ADDENDUM NO. TWO (2)
TOWN OF BRASELTON, GEORGIA
2026 GROUNDWATER EXPANSION AND DISTRIBUTION STORAGE
ISSUED JANUARY 23, 2026

RE: 2026 GROUNDWATER EXPANSION AND DISTRIBUTION STORAGE
EMI PROJECT No. 18-021

The purpose of this Addendum is to provide the omitted storage tank drawings, existing contours for treatment site, the pre-bid meeting attendance, and add Precon Corporation as a pre-approved concrete storage tank manufacturer. The following items of the Contract Documents are modified as part of this Addendum:

M9
SHEET

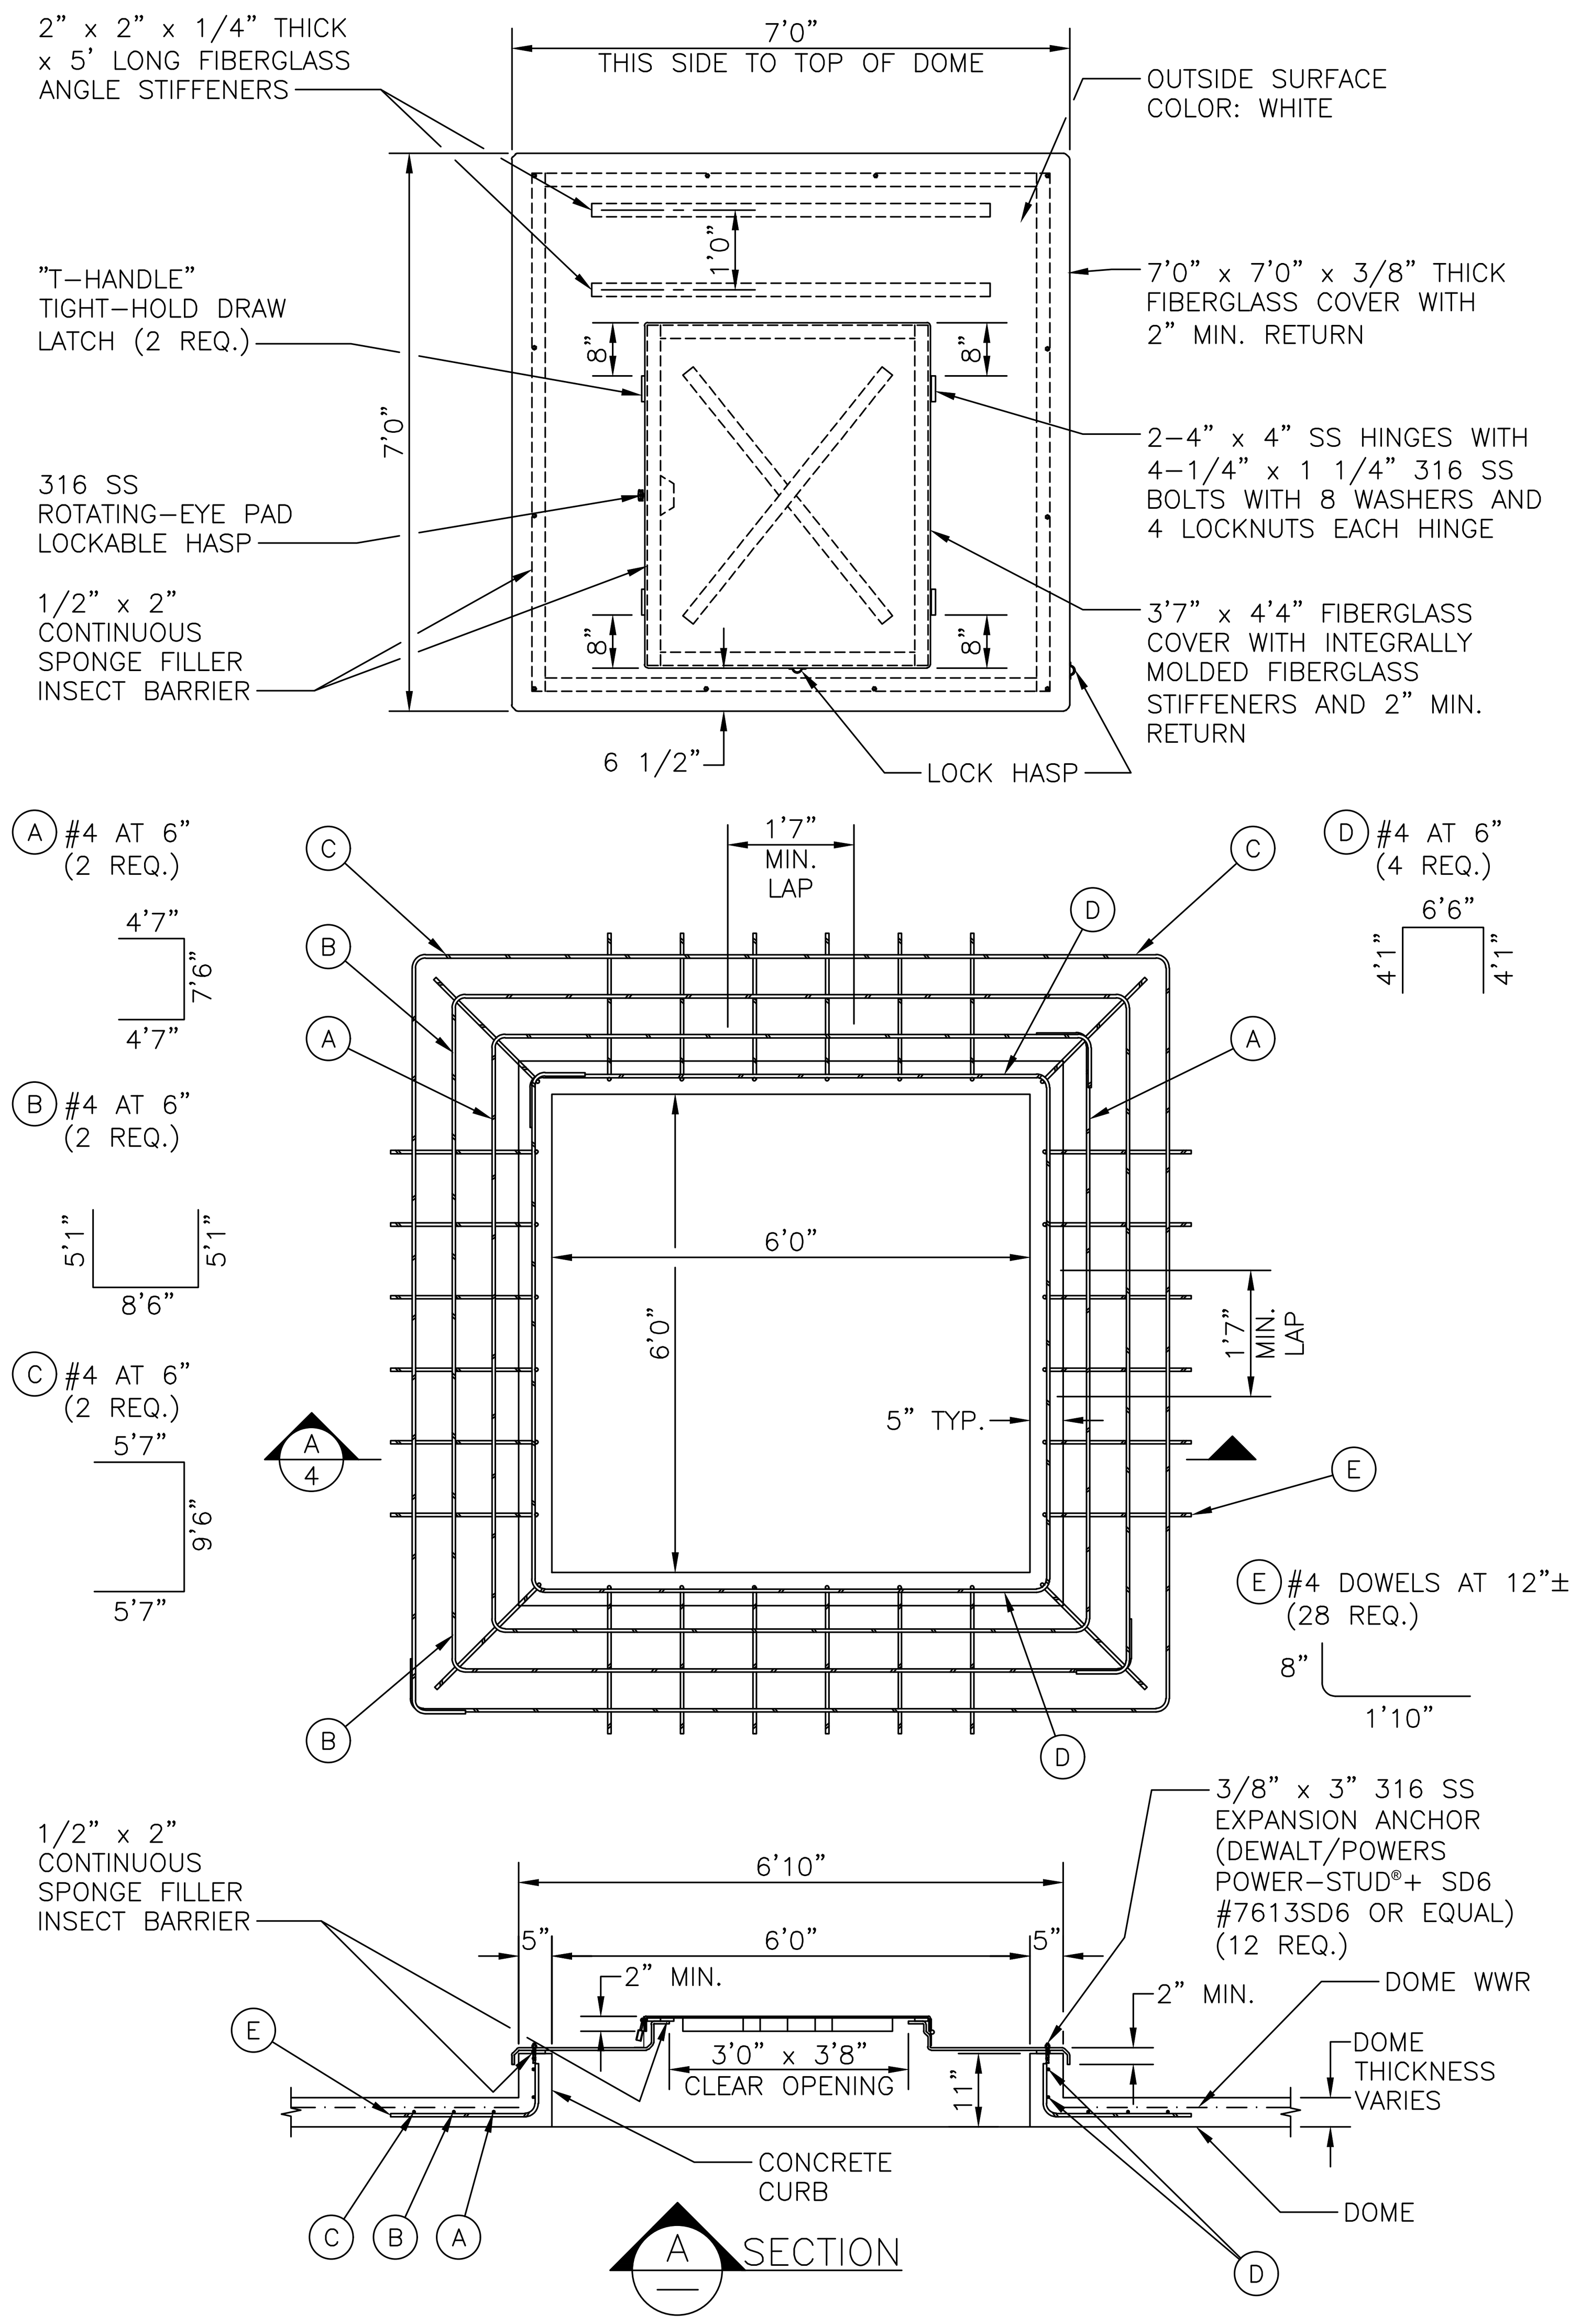
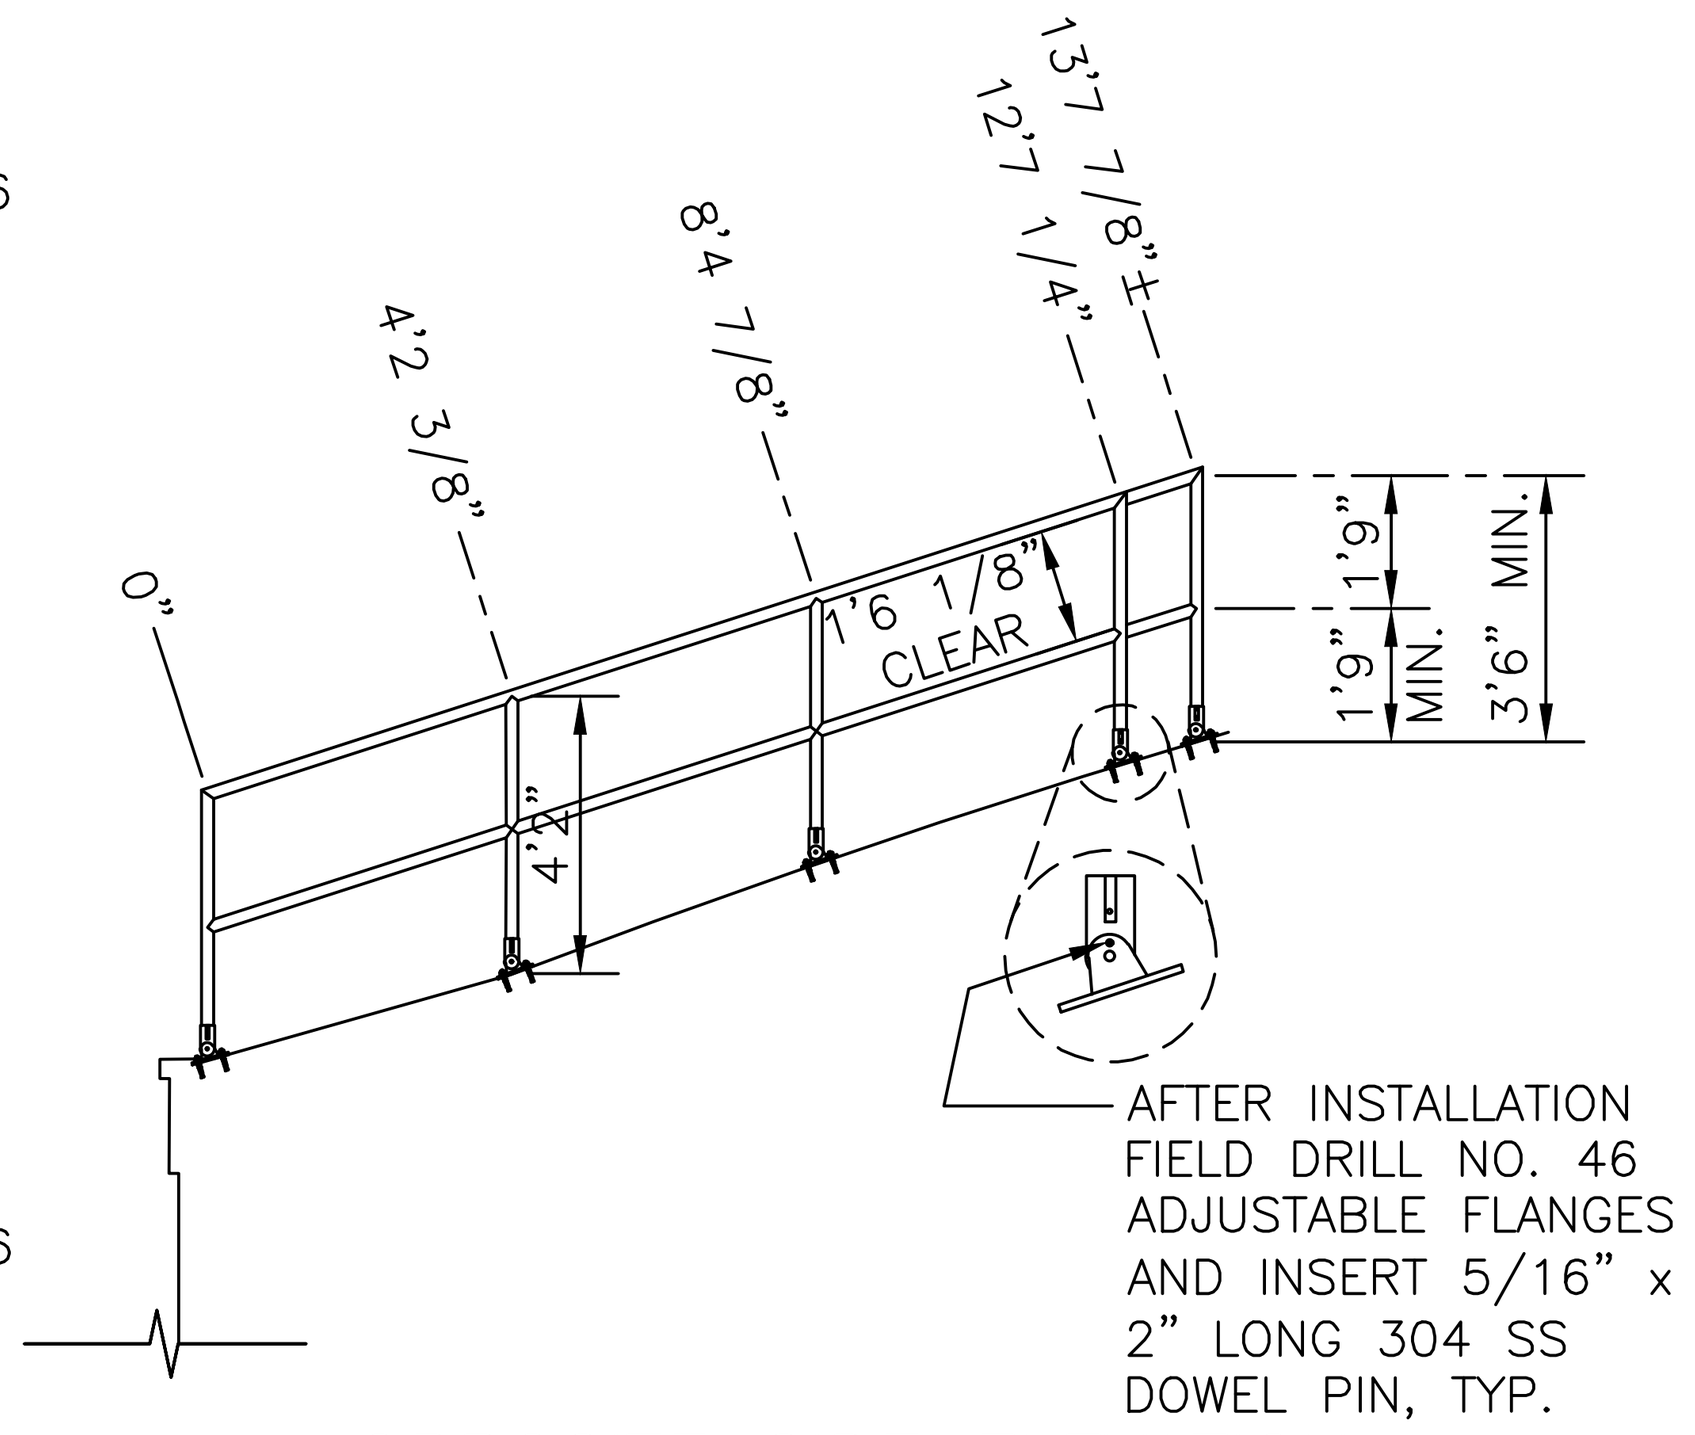
1. The contract documents appear to be missing plan sheets M7-M10 for the new tank listed in the sheet index. Can you please provide the missing drawings?

- <u>*Plan sheets M7-M10 have been provided to show plans for the concrete storage tank. See attached plan sheets.*</u>

EMI Response: Sheets M7-M10 were omitted in error. Please see the original sheets attached to this addendum.
